<b>Issue Date</b>	9 October 2023	<b>RFI No.</b>	RFI 10
<b>Attention</b>	██████████	<b>Date required</b>	<b>18 October 2023</b>
<b>Originator</b>	██████████		
<b>Subject</b>	Proposed investment and unquantified benefits, short list of options, Sensitivity Analysis

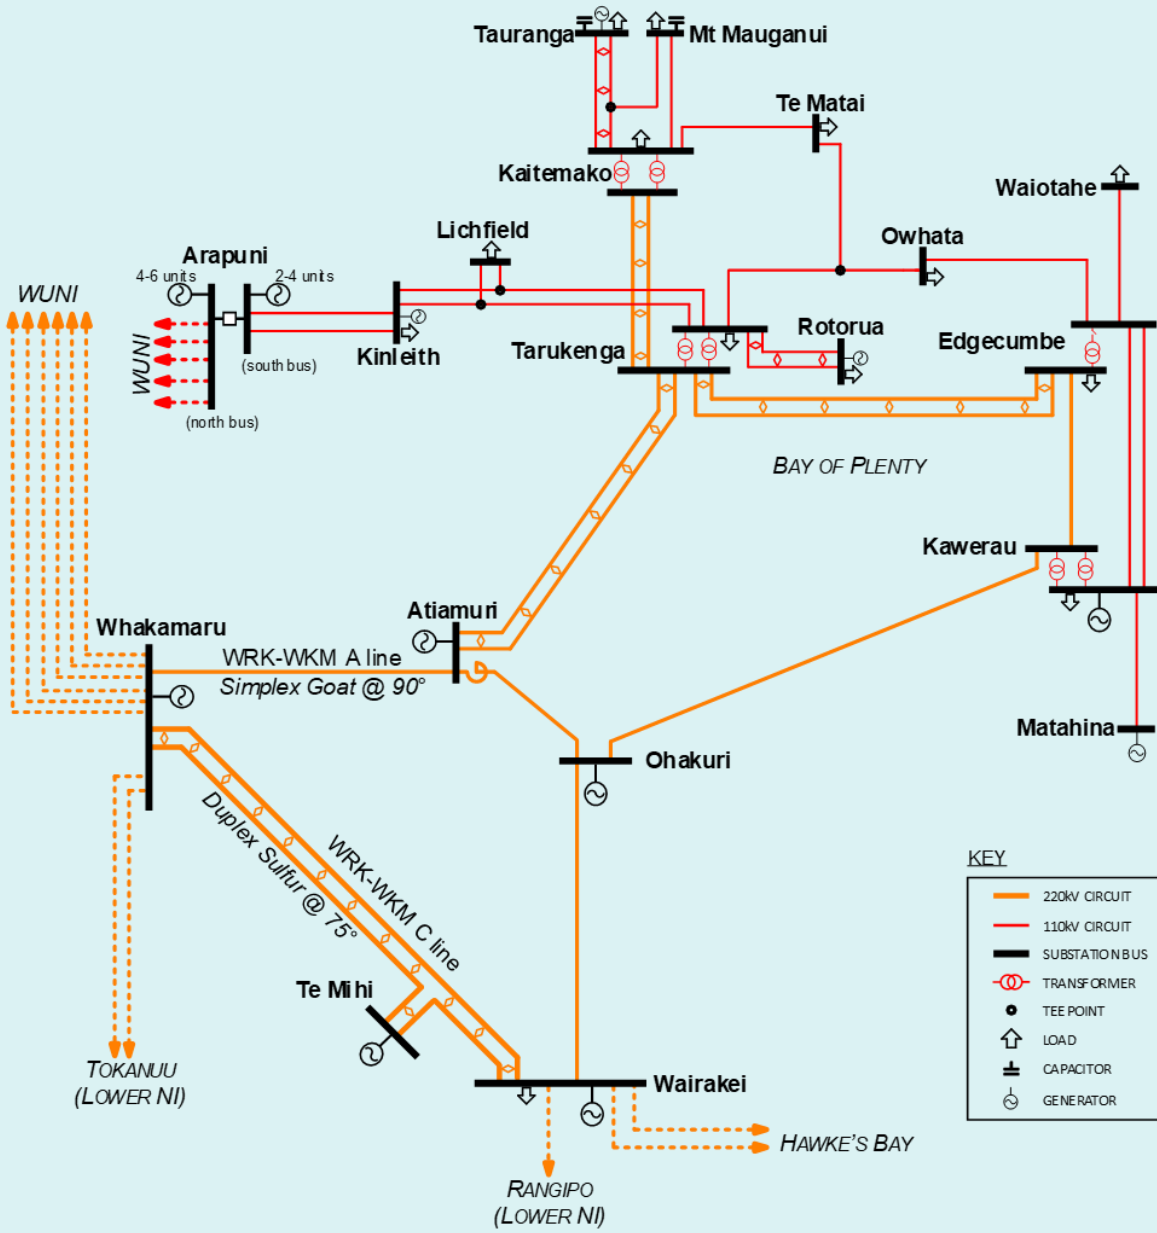
For Wairakei ring upgrade, the Updated Proposal mention “replace WRK-WKM A line”. In Attachment C, this workstream component is described as “New 220kV line from Wairakei to Ohakuri and upgrade existing Ohakuri-Whakamaru section of the Wairakei-Whakamaru A line to a 220kV duplex line.”

#### **Please clarify how replacing the WKM-WRK A line will provide n-1 security to the BOP under maintenance.**

Our current view is that BOP will be on N security when two of the existing lines (eg, either the OHK-WRK line or the ATI-WKM line) are out for maintenance.

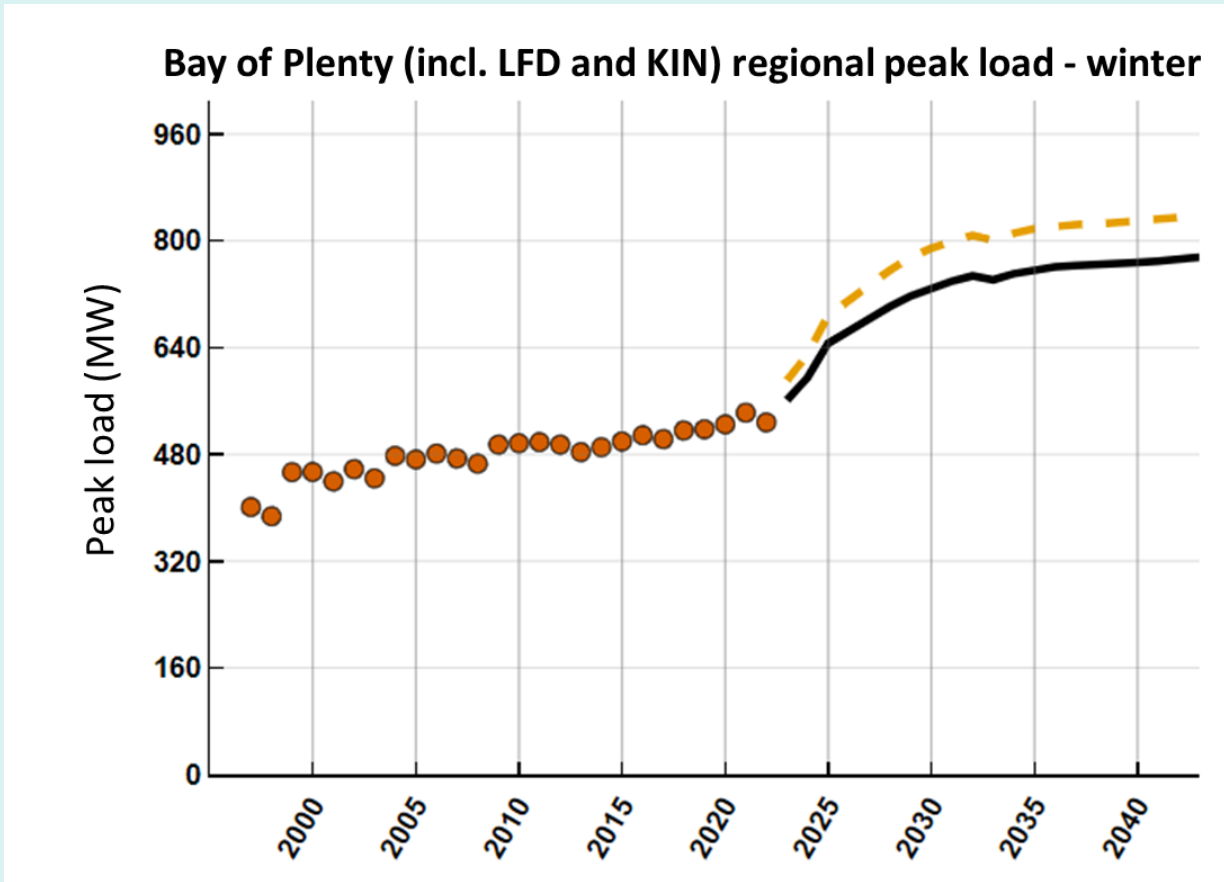
We also question the merits of providing n-1 transmission security to BOP if there is a cost premium. This is because the Bay of Plenty has reasonable spread of generation using the three main renewable generation technologies – hydro (at least 147 MW), geothermal (approx. 167 MW) and solar.

**Since generation is an acceptable alternative to transmission, what is the advantage of further investment in transmission to provide n-1 under all operating conditions?**

The Bay of Plenty region has a growing amount of installed generation capacity from different technologies. However, it is important to remember that solar without BESS does not help to cover the morning and evening peaks. Hydro generation in the Bay of Plenty does help to some extent in reducing the regional net load, but this help cannot always be relied on due to the limited storage capacity of most of the hydro schemes in the region.

We must also keep in mind that we are expecting a major load increase in the region, mostly in the western region (see the forecast below from our latest Transmission Planning Report). Because periods of high generation do not necessarily coincide with periods of high load (especially for solar and hydro generation with limited or no storage capability), we expect that in the next 25 years the Bay of Plenty region will at times experience significantly higher net loads, and at other times significantly higher net generation excess than what we experience now.

During periods of higher net load (winter peak load in low hydrology conditions), maintaining n-1 security with the existing grid will become increasingly challenging. During periods of higher net generation excess (summer midday on a sunny day with high hydrology), the existing WRK-WKM A line will limit the amount of generation that can be exported from the Bay of Plenty. Replacing the A line (where the Atiamuri–Ohakuri - Wairakei section is replaced and the Atiamuri – Whakamaru section is duplexed, as proposed in Option 14). Note that it is possible the 220 kV regional lines within the Bay of Plenty might also require an upgrade at some point in the future for the

**Figure 9: Wairakei Ring maximum transfer capacity with and without WRK-WKM C line TTU**

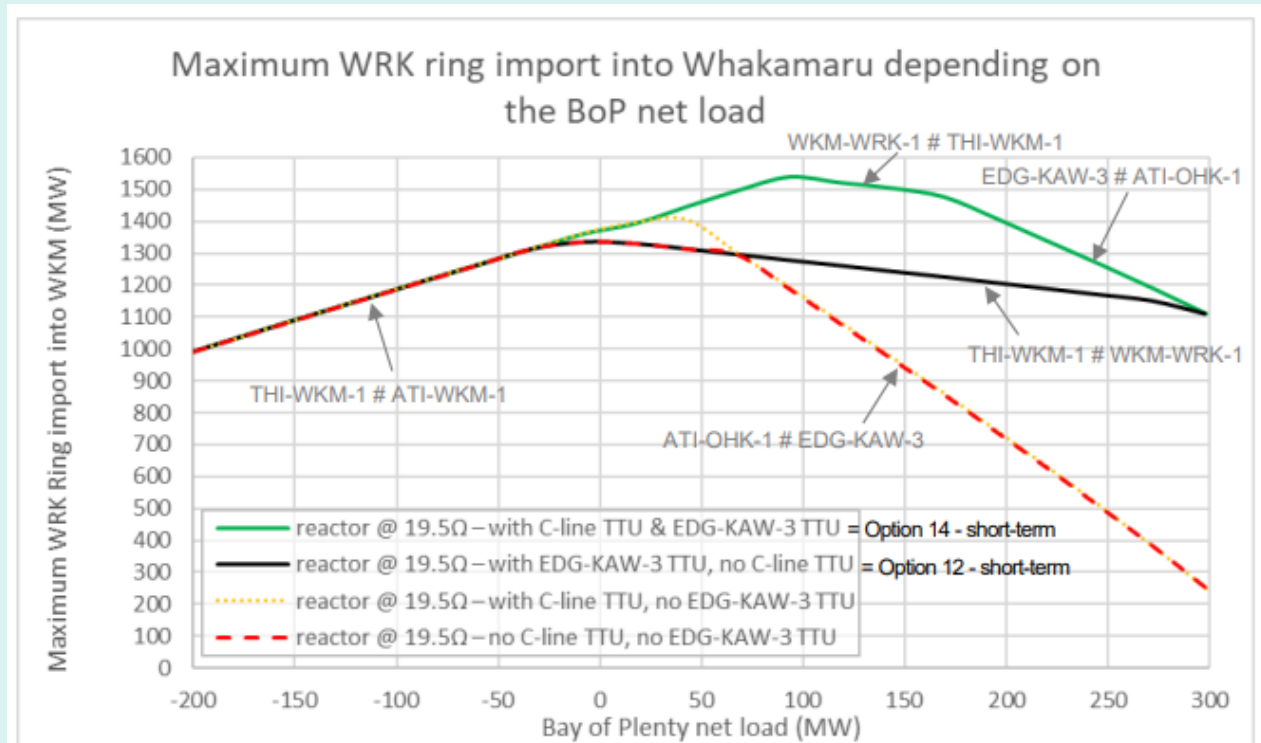
**If WRK ring stage 2 is justified and required, to meet the investment need, please clarify why replacing WRK-WKM A line is proposed ahead off a new WRK-WKM D line. The clarification needs to clearly state the quantified and unquantified benefits.**

From a load flow perspective, the figure below (from our proposal, Attachment B) illustrates how the short-term (Stage 1) upgrade proposed in Option 14 impact the grid transfer capacity from Wairakei to Whakamaru. Option 12 is represented by the black line, while Option 14 is indicated by the green line. The data illustrates that Option 14 can provide up to an additional 250MW of capacity compared to Option 12, specifically during periods of low to medium Bay of Plenty load. It is worth noting that neither Option 12 or 14 will provide a transfer capacity increase during times of generation excess in the Bay of Plenty region. Given that the peak load in the Bay of Plenty typically aligns with the national peak load, it is anticipated that the additional capacity provided by Option 14 will be useful during peak periods.
